### APPEAL SUMMARY

<b>Appeal ID:</b> 22222	<b>Project Address:</b> 3181 SW Sam Jackson Park Rd
<b>Hearing Date:</b> 12/18/19	<b>Appellant Name:</b> Tom Jaleski
<b>Case No.:</b> B-001	<b>Appellant Phone:</b> 9712385266
<b>Appeal Type:</b> Building	<b>Plans Examiner/Inspector:</b> Maureen McCafferty
<b>Project Type:</b> commercial	<b>Stories:</b> Occupancy: B, A-3, A-2 <b>Construction Type:</b> B, A-3, A-2
<b>Building/Business Name:</b> OHSU – Casey Eye Institute	<b>Fire Sprinklers:</b> Yes - Throughout
<b>Appeal Involves:</b> Erection of a new structure	<b>LUR or Permit Application No.:</b>
<b>Plan Submitted Option:</b> pdf [File 1]	<b>Proposed use:</b> Clinic / Office

# OHSU ECEC

### Fire Rating of 3" x 3" x 1/4" HSS Member

Fig 1a: Elevation of 3" x 3" x 1/4" HSS section

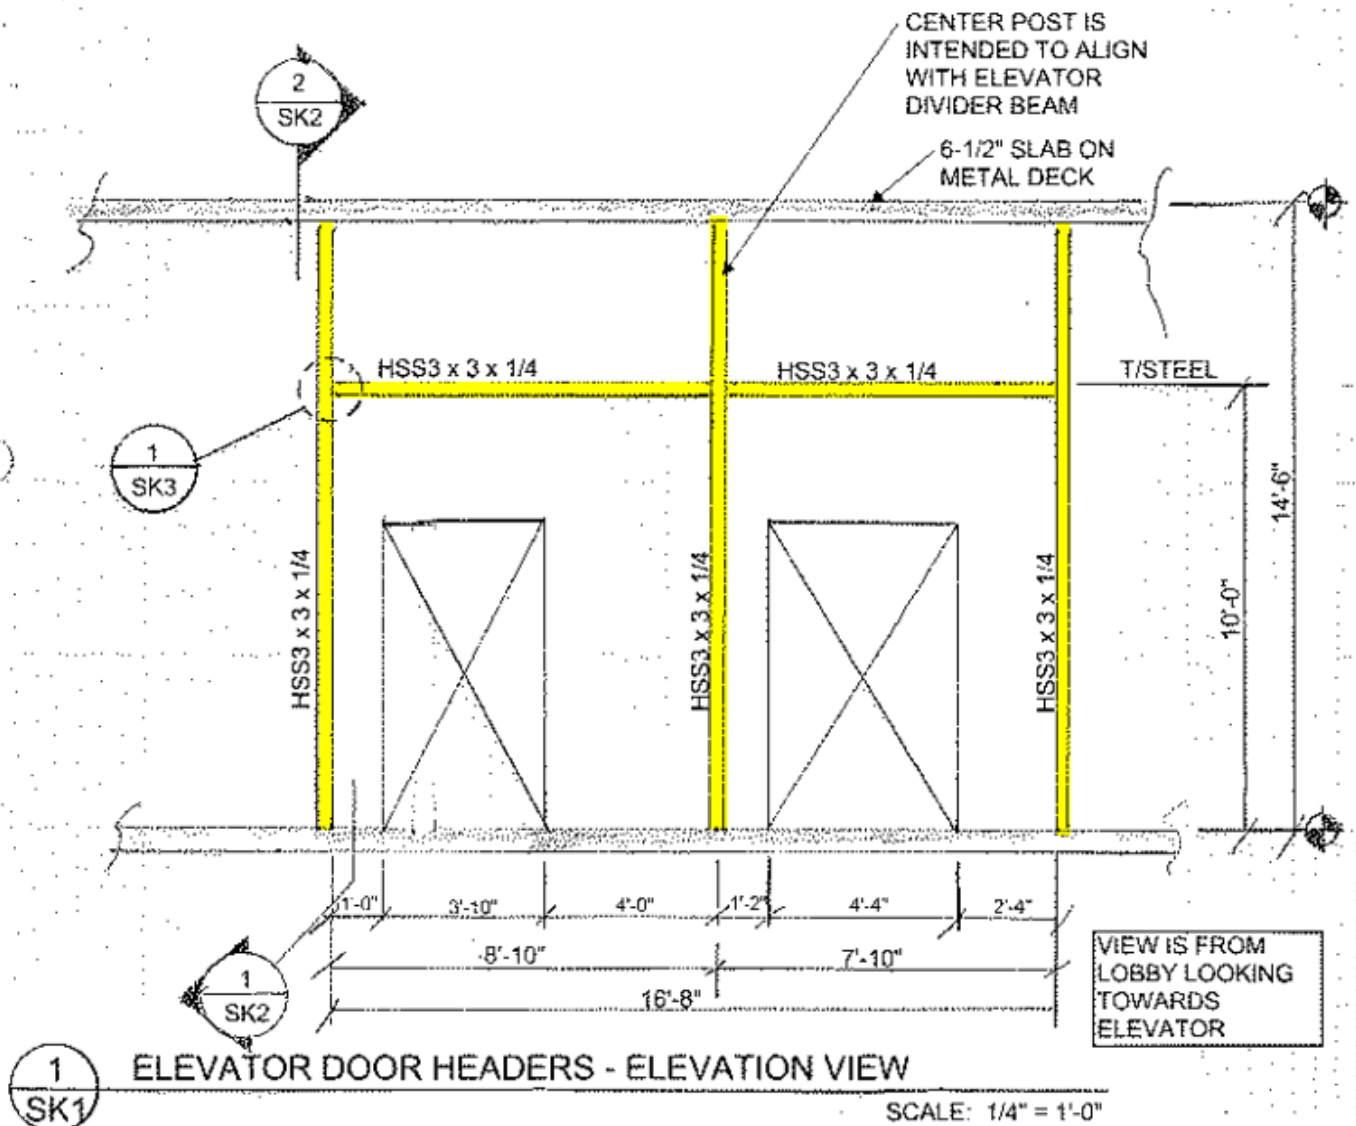
The proposed member assembly consists of 3 x 3 x 1/4" HSS section with a minimum of two layers of 5/8" Type X gypsum board installed on the exposed faces as shown in Figure 1b.

Fig 1b: Proposed vertical assembly of 3" x 3" x 1/4" HSS plan view

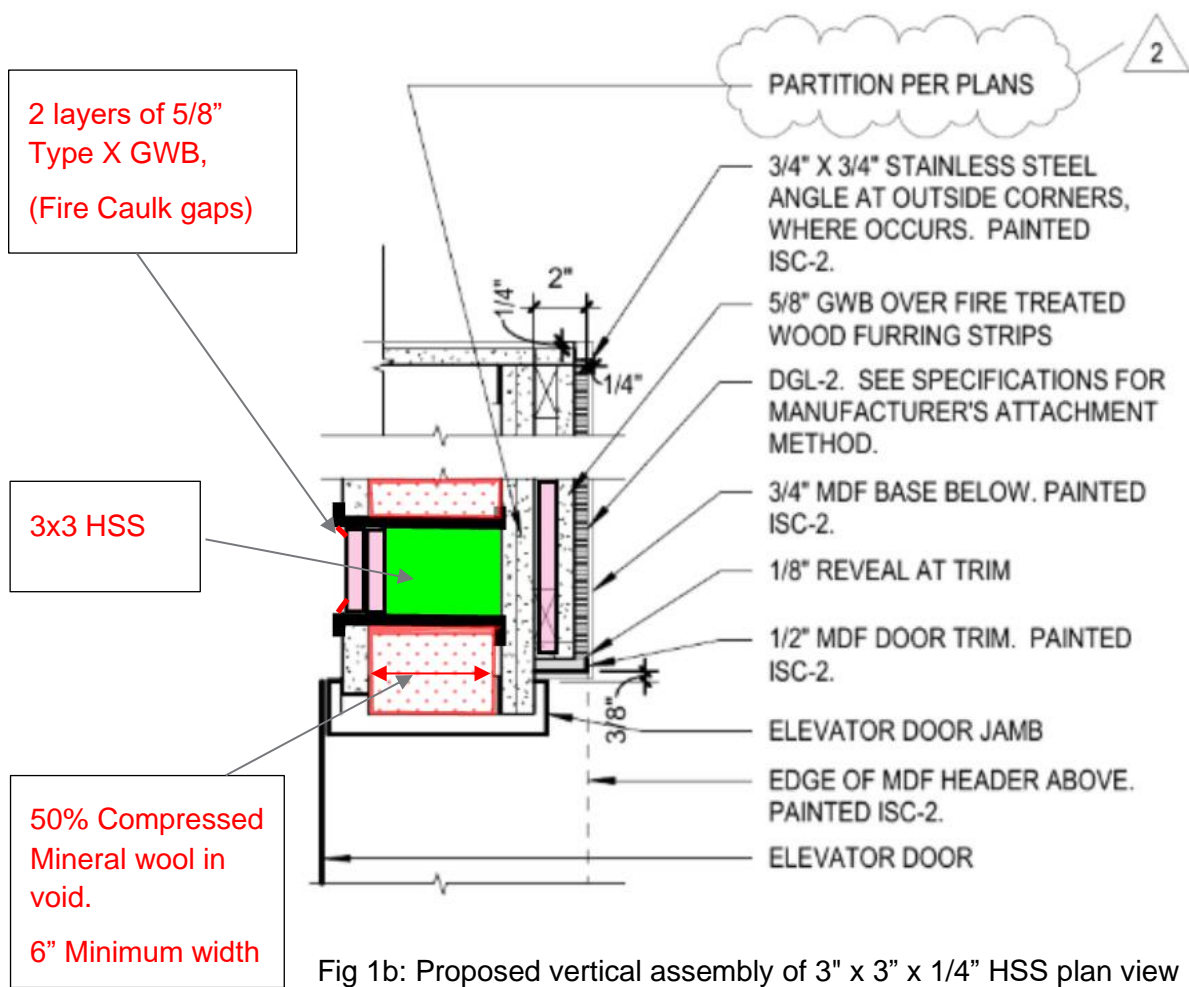
**Proposed Design** The HSS Member is to be installed within a 2-hour rated shaft wall. The primary function of the member is providing stiffening of the wall at elevator doors. Membrane protection will be provided, as complete encapsulation protection per 704.3 will not be required as the members do not support a load bearing wall. The shaft wall is attached to the columns and is therefore self-supporting.

The proposed member assembly consists of 3 x 3 x 1/4" HSS section with a minimum of two layers of 5/8" Type X gypsum board installed on the exposed faces as shown in Figure 1b of the EJ.

**Reason for alternative** The HSS member is not part of a UL listed as a fire rated assembly. Since it is part of a shaft enclosure connecting four or more stories, it is required to be 2-hour fire resistance rated per 2014 OSSC §713.4.

When evaluated with exposure from one side, the proposed steel tube beam is thicker and provides greater heat resistance than the UL tested beam and therefore requires less added fire protection material than the UL tested assembly. The proposed member will be heated only from the interior, shaft facing side. Two layers of 5/8" type X GWB provide protection for the shaft exposed face, while compressed Mineral Wool ensures heat will not be transferred through the cavity.

**Alternate 2 hour fire rated HSS assembly with engineering analysis: Granted as proposed.**

Figure 2: UL N502 Assembly

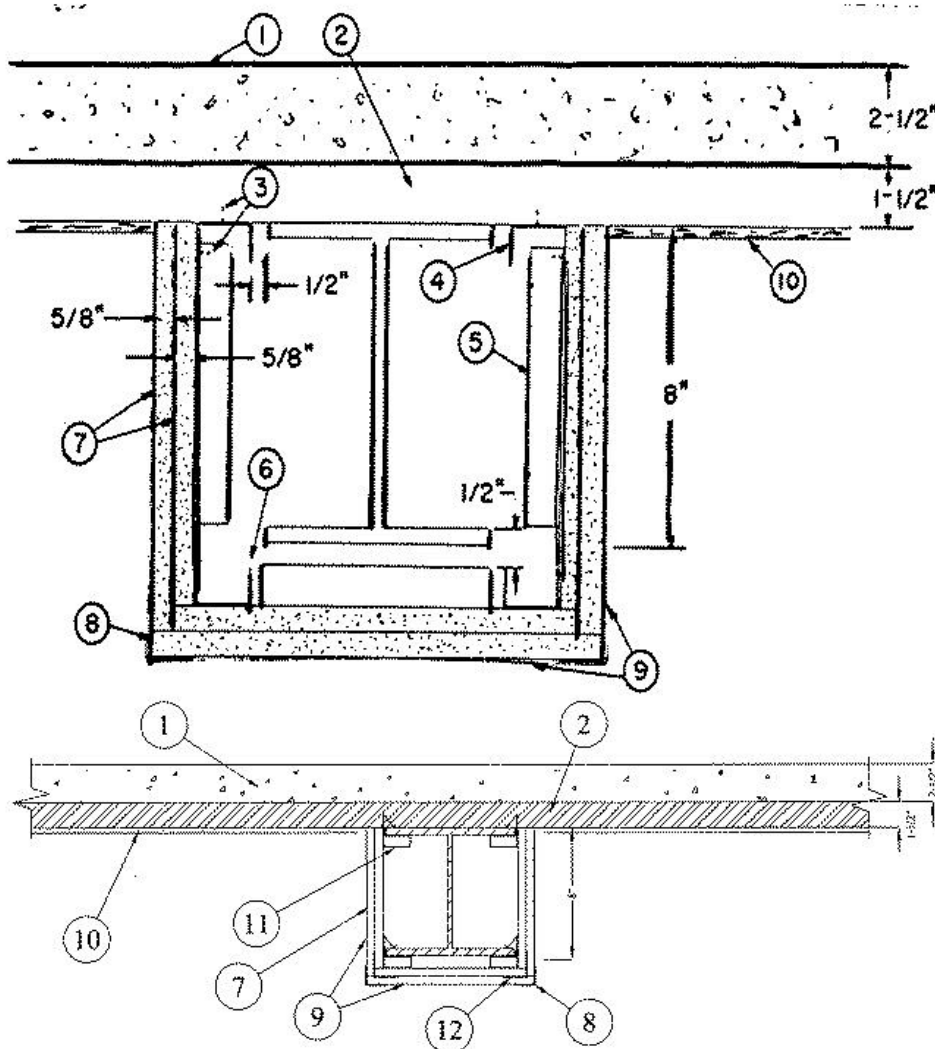
The proposed assembly of HSS 3" x 3" x 1/4" as the primary structural member is an alternate to the W8 x 24 used in the test assembly N502 as shown in Figure 2.
